PARTY'S NAME	SUN GLOW GREEN SOLUTIONS PVT. LTD., NEW DELHI
PARTY'S DRAWING No.	AS PER DRAWING & REQUIREMENT
ALLOY & TEMPER	6063 T6
DESCRIPTION	H-PROFILE

DRAWING No.	SECTION No.
P-19077-1	–
S6136	S6136(ISSUE-2)

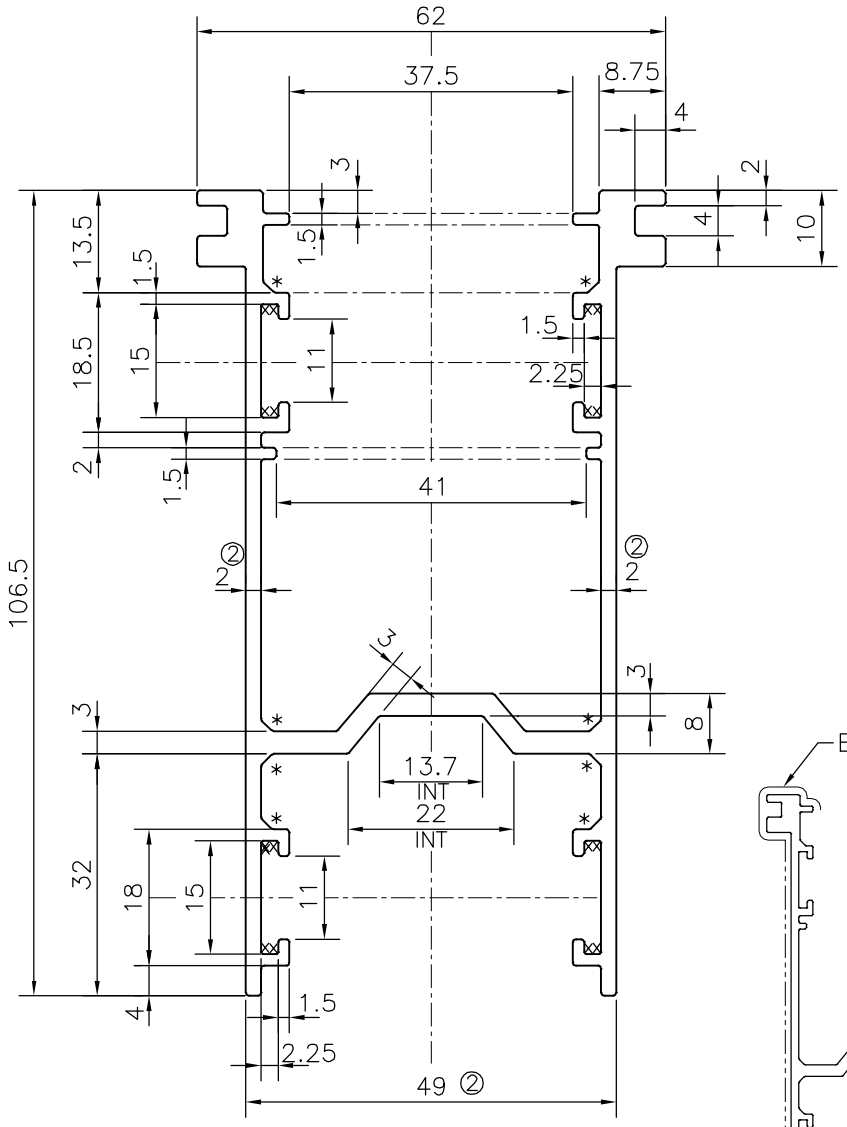
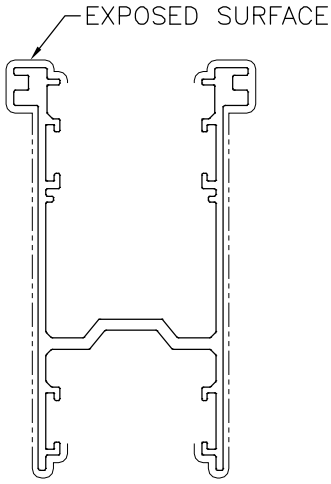
ISSUE-2
DIMENSION CHANGED FROM 48 mm TO 49 mm &
THICKNESS CHANGED FROM 1.5 TO 2.0 mm
WEIGHT ALSO CHANGED FROM 1.838 TO 2.099 kg/m
